Dr. Jacob Paz
402 Greenbrier St # 47
DeRidder, LA 70634

U.S. Nuclear Regulatory Commission
Mail Stop O-16G4
Washington, DC 20555-0001

July, 28 2008

A Review of Health Risks due to Complex Mixtures in a Geologic Nuclear Waste Repository

Figure 1. Generalized relationship of radiological and chemical risk at nuclear waste (Persson 1990)

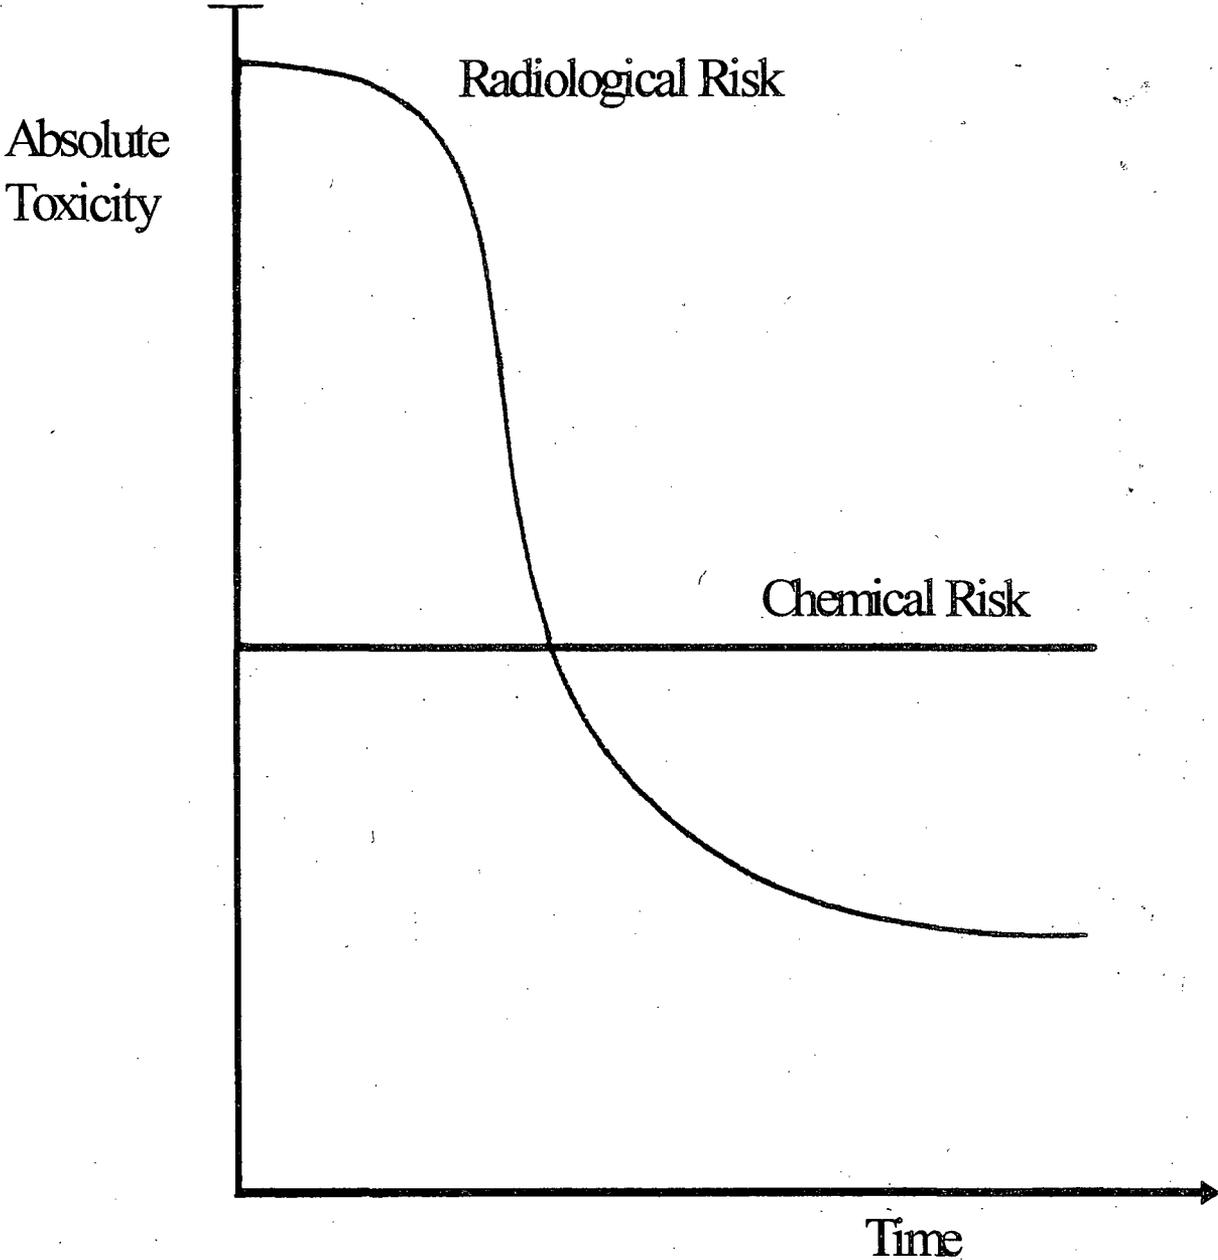
In contrast, to (Persson 1990) statement that absolute chemical toxicity will remain constant at a high level nuclear repository, the authors believe as time progresses the absolute toxicity will increase due to: First, the authors believes that there will be an increase in the magnitude of the absolute toxicity due to synergistic interactions among Cr, Ni, Ni, and Ti heavy metals however no value can be set. Another aspect (is it shown in Figure 2. Shows there are possibility synergetic interactions between Ni and Cr both known potent carcinogens and subsequently increase in cancer risk. We can not assign a value for the health risk because of lack of applicable data. Finally, the conversion of actinides into Pb, eventually could also increased the again the chemical toxicity will start to increase as time progresses. The decay of actinides, such as uranium and plutonium, in the fuel will result in the formation of significant quantities of lead in repository as time progresses. For every metric ton of buried waste (Pu) 325 grams of lead will be produced within a one million years. For a repository containing 77,000 metric tons of waste, over 25 metric tons of lead will be created by decay. In addition, as it shown in figure 3, spent nuclear fuel within a high-level nuclear waste repository will radioactively decay producing new nuclides.

5. In contrast to Persson (1990), who stated that absolute chemical toxicity will remain constant at a high level nuclear repository, the authors believe that due to the conversion of actinides into lead, the chemical toxicity will start to increase as time progresses and the absolute chemical toxicity will increase over time. In YMP there is a good possibility of synergistic interaction among heavy metals and subsequently this could increase in the absolute toxicity and cancer risk to populations.

Figure 2. Hypothetical changes in absolute chemical risk in a geological repository due to interactions among Cr, Ni, and Ti, and the Conversion of Actinides into Pb.

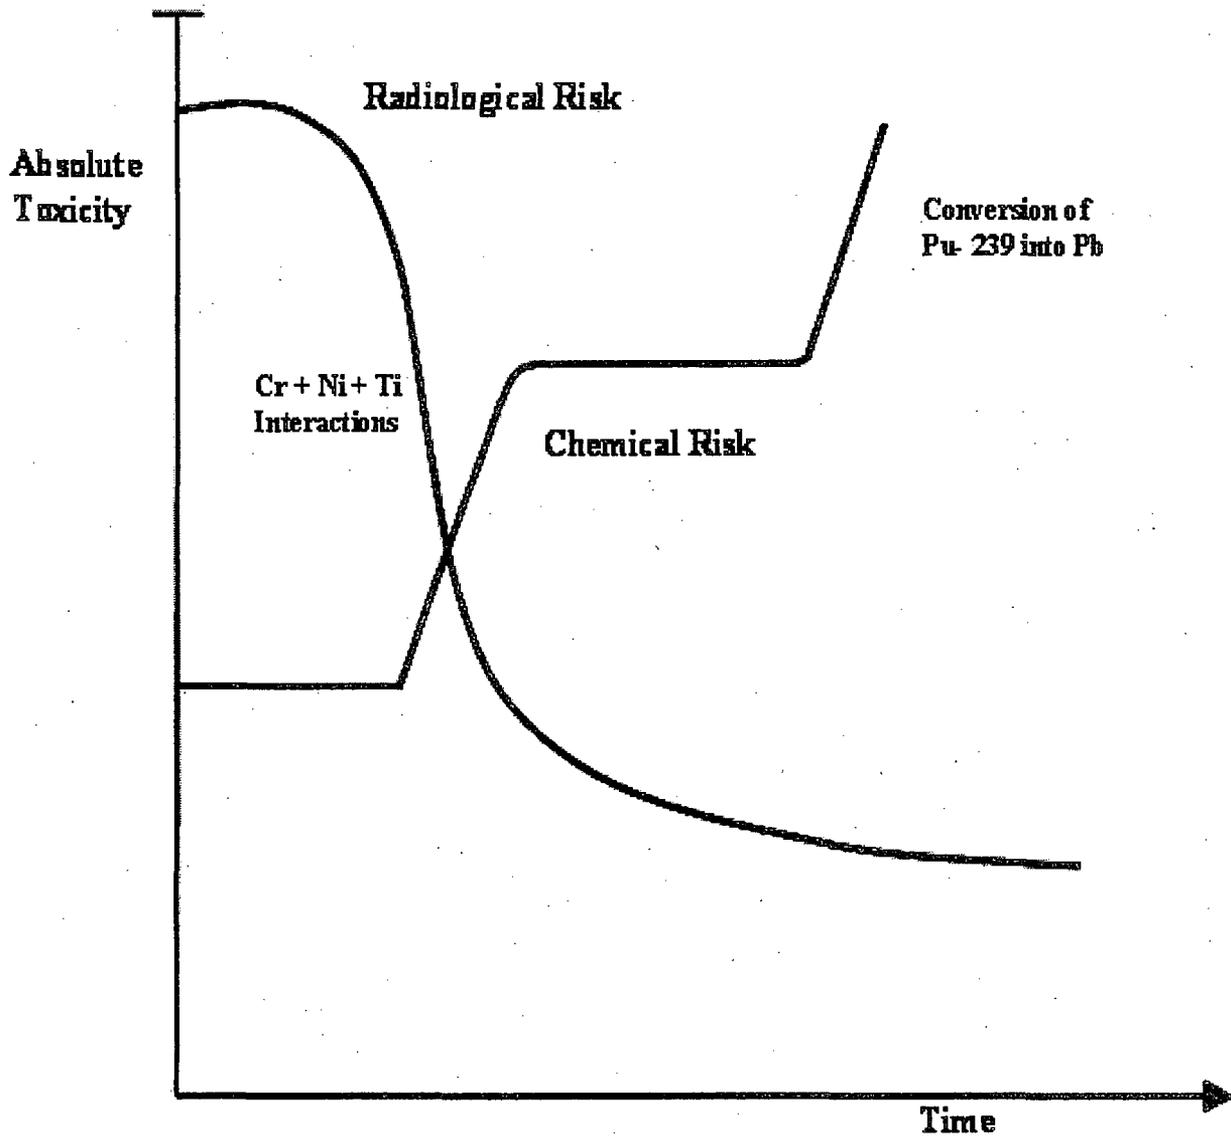
Fig.2. Shows changes in absolute chemical risk in a geological repository due to the possible synergistic interactions among heavy metals and possible synergistic interaction between Ni, Cr and Ti both known carcinogens, and the Conversion of Actinides (^{239}Pu into Pb).

Figure 3. Illustrate the Calculated Radioactive Decay of Plutonium into Lead in Spent Nuclear Fuel at a Nuclear Repository

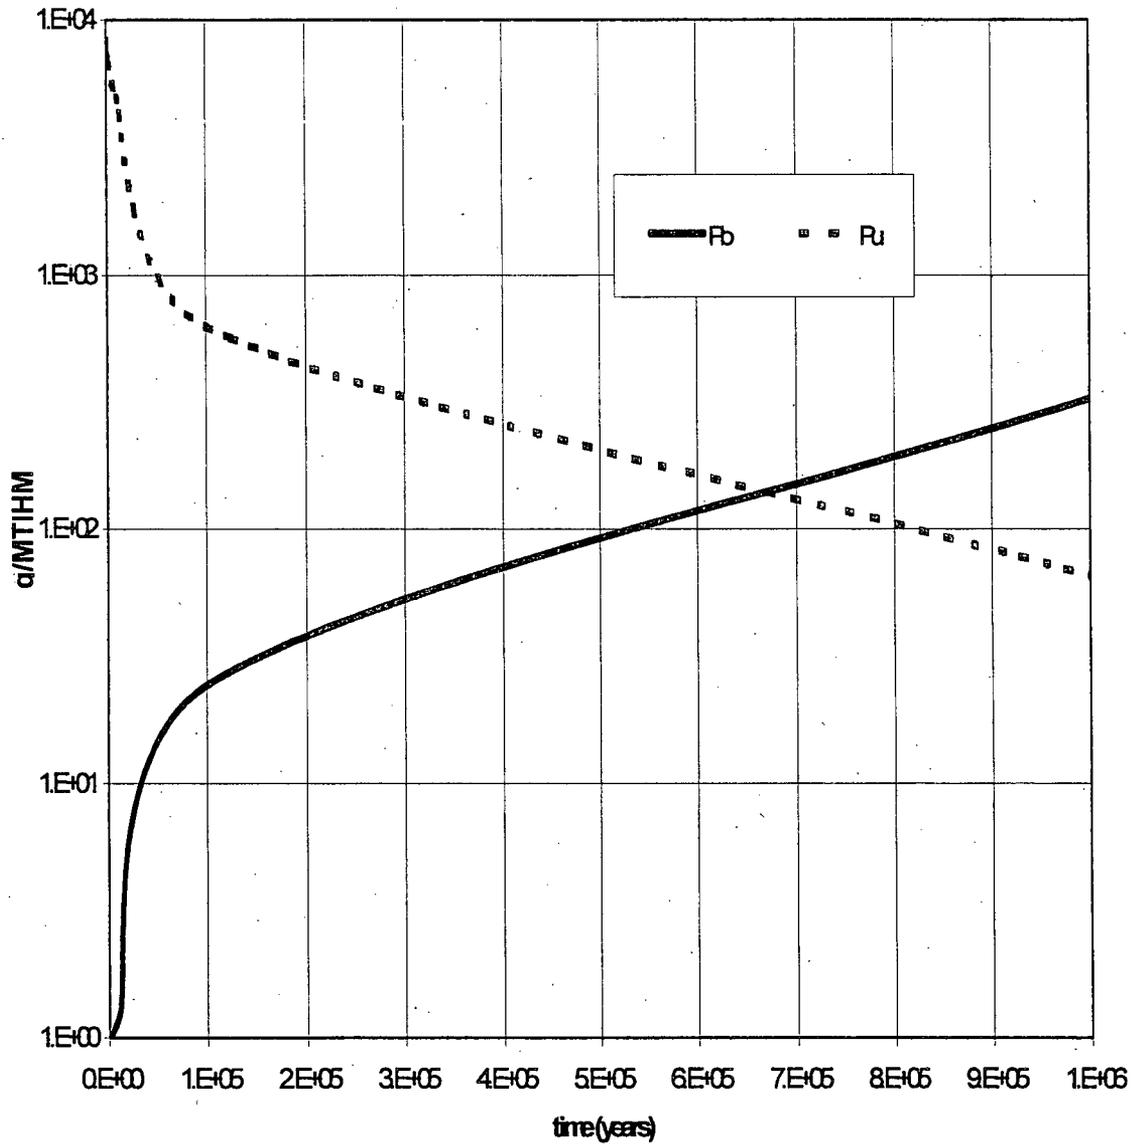
Figure 3 Illustrates the Calculated Radioactive Decay of ^{239}Pu into Lead in Spent Nuclear Fuel at a Nuclear Repository.

The decay in the fuel of actinides, such as uranium and plutonium, will result in the formation of significant quantities of lead in the repository as time progresses. For every metric ton of buried waste (^{239}Pu) 325 grams of lead will be produced within one million years. For a repository containing 77,000 metric tons of waste, over 25 metric tons of lead will be created by decay.
